**UPPER MORELAND TOWNSHIP**  
**Community Development Committee Meeting**  
**February 9, 2026 at 7:00 p.m.**  
***AGENDA ITEMS ARE SUBJECT TO CHANGE***

- A. Land Development Waiver Request - 601 Davisville Road Fred Beans (attachments)
- B. Land Development Waiver Request – 3930 Commerce Avenue (attachments)

RECORD PLAN  
LAND DEVELOPMENT WAIVER  
601 DAVISVILLE ROAD  
UPPER MORELAND TOWNSHIP - MONROE COUNTY - PENNSYLVANIA  
MUNICIPAL CIVIL CONSULTING ENGINEERS, INC.  
1108 North Bethlehem Pike, Suite 5 - Lower Gwynedd - PA 18002  
Phone: (215) 542-5648 Web: [www.woodrowinc.com](http://www.woodrowinc.com)

EXISTING FEATURES AND  
DEMOLITION PLAN  
607 DAVISVILLE ROAD  
UPPER MORELAND TOWNSHIP - MONTGOMERY COUNTY - PENNSYLVANIA  
WOODROW & ASSOCIATES, INC.  
MUNICIPAL / CIVIL CONSULTING ENGINEERS  
1108 North Broad Street, Philadelphia, PA 19102

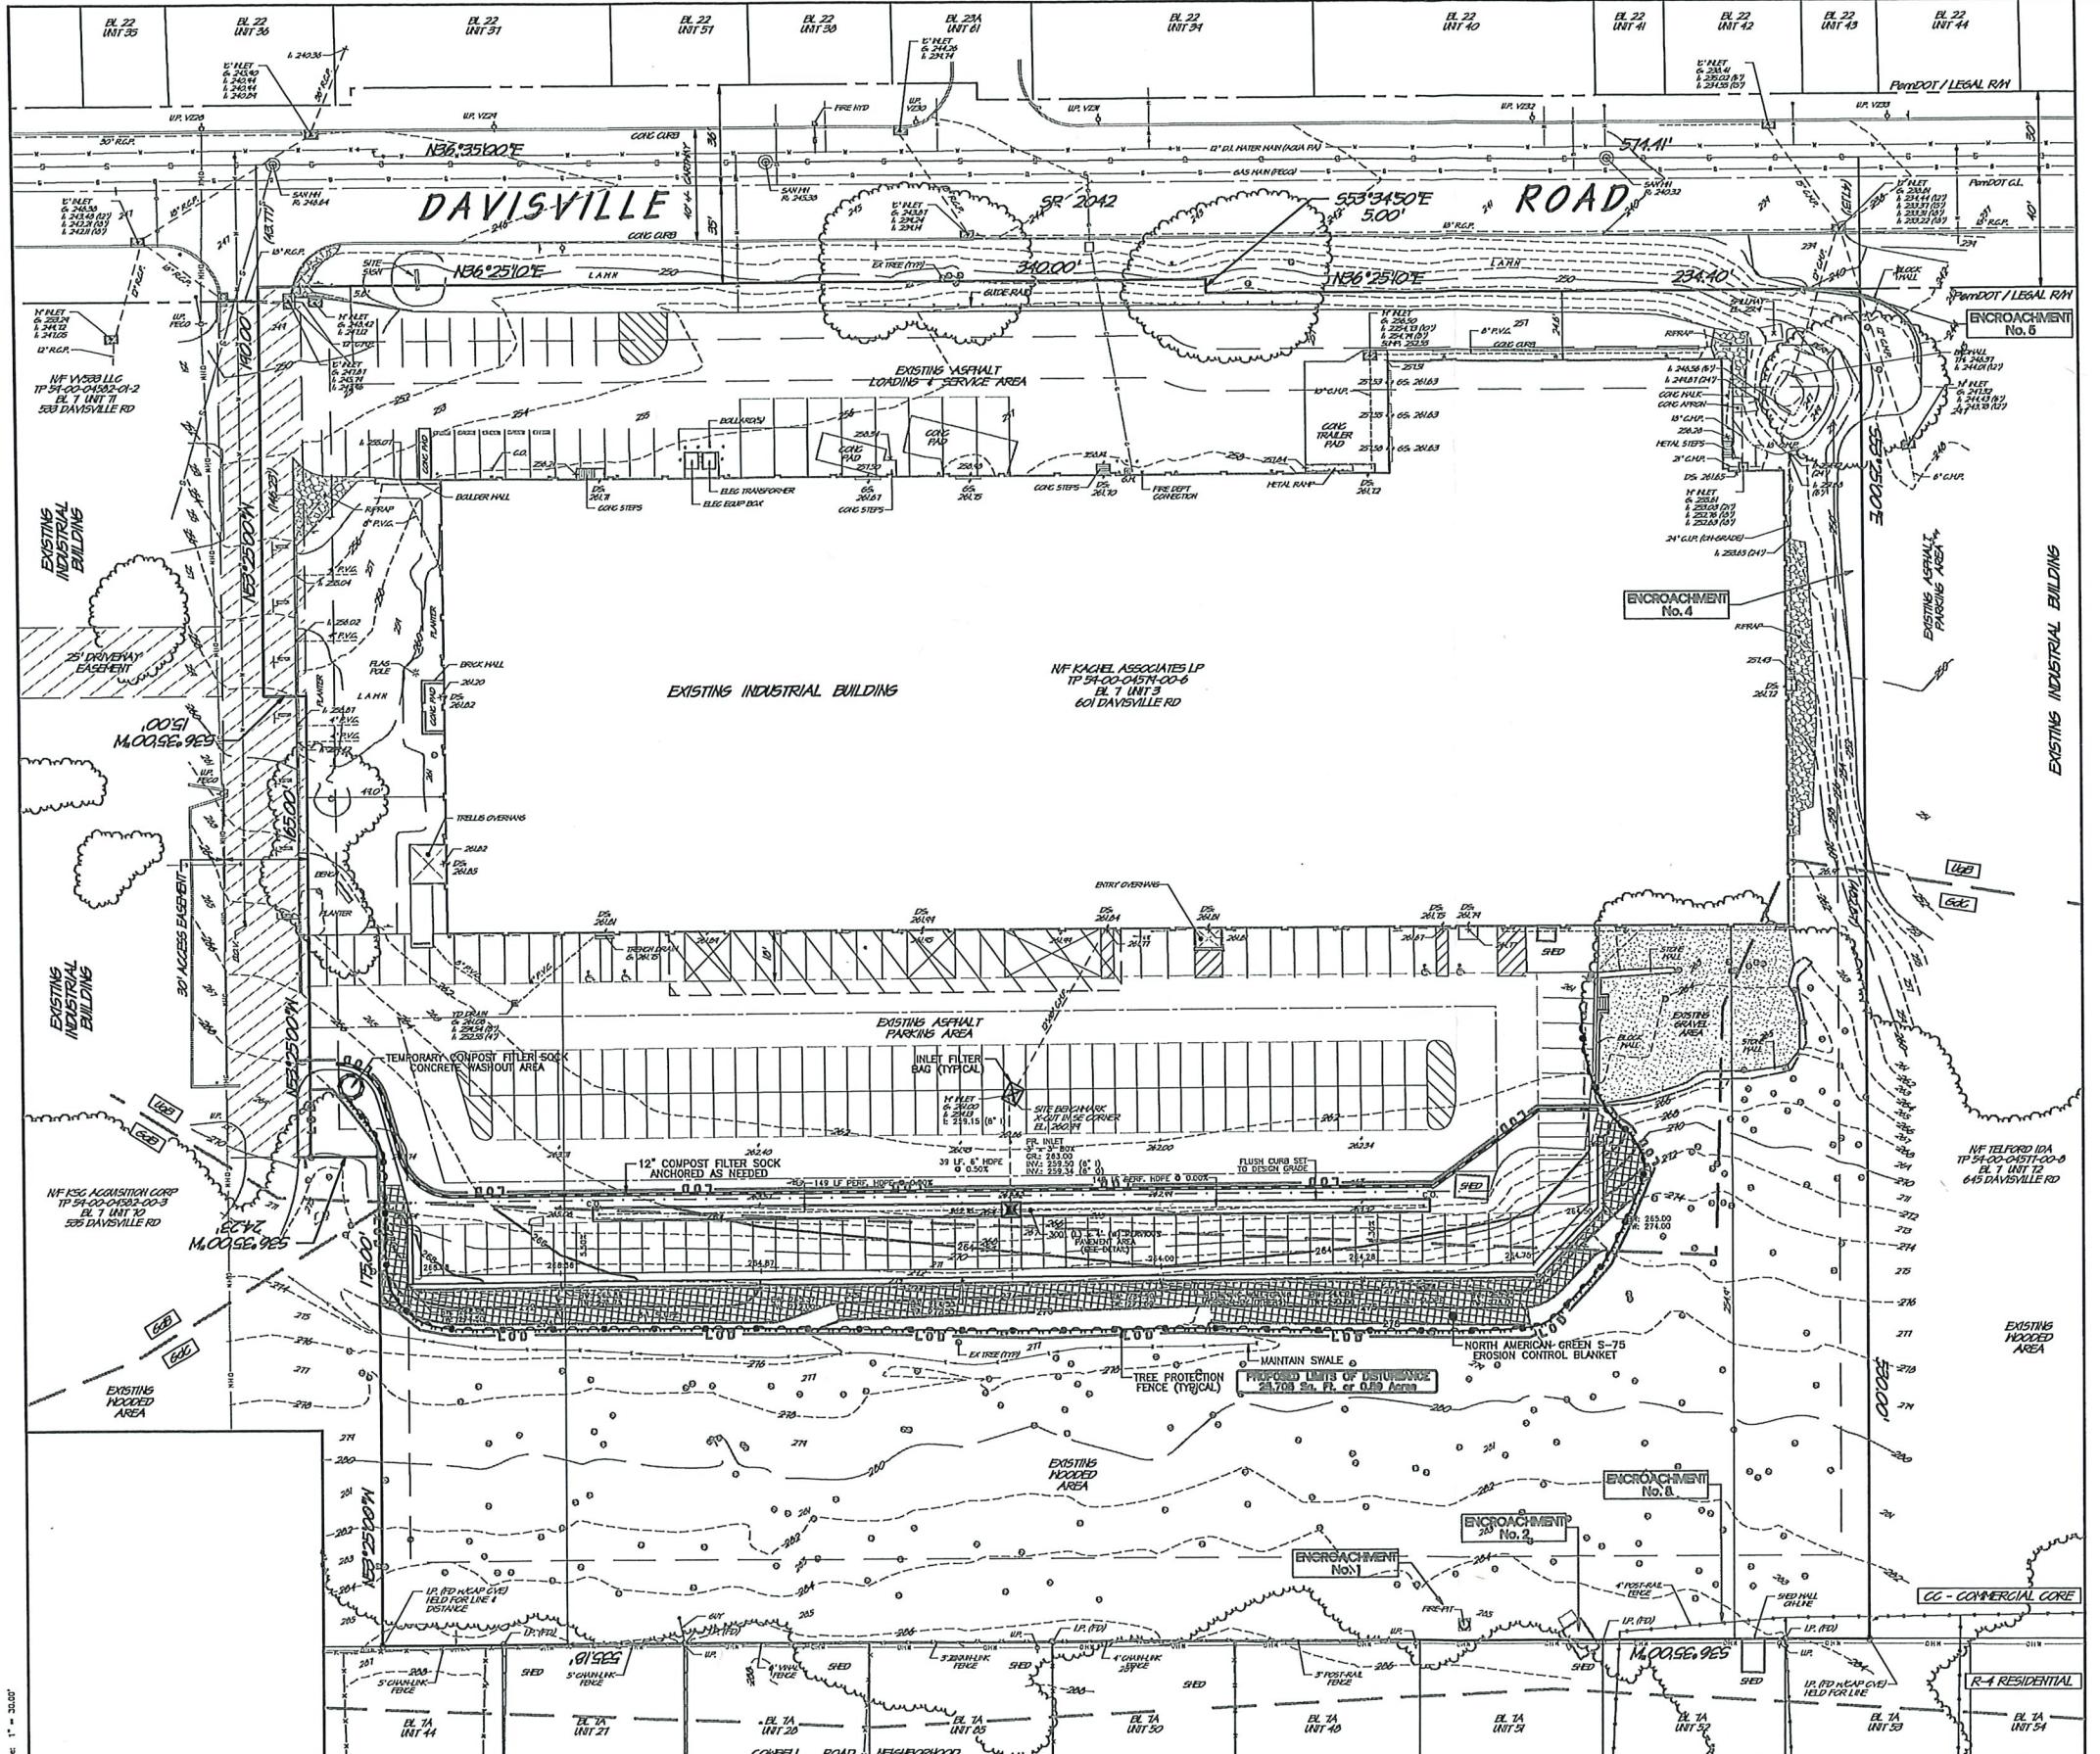
1. Verify the existing on-site parking spaces listed on Sheet 2 as the quantity listed seems low.
2. We suggest using wheel stops on the eastern parking/storage spaces along the retaining wall.
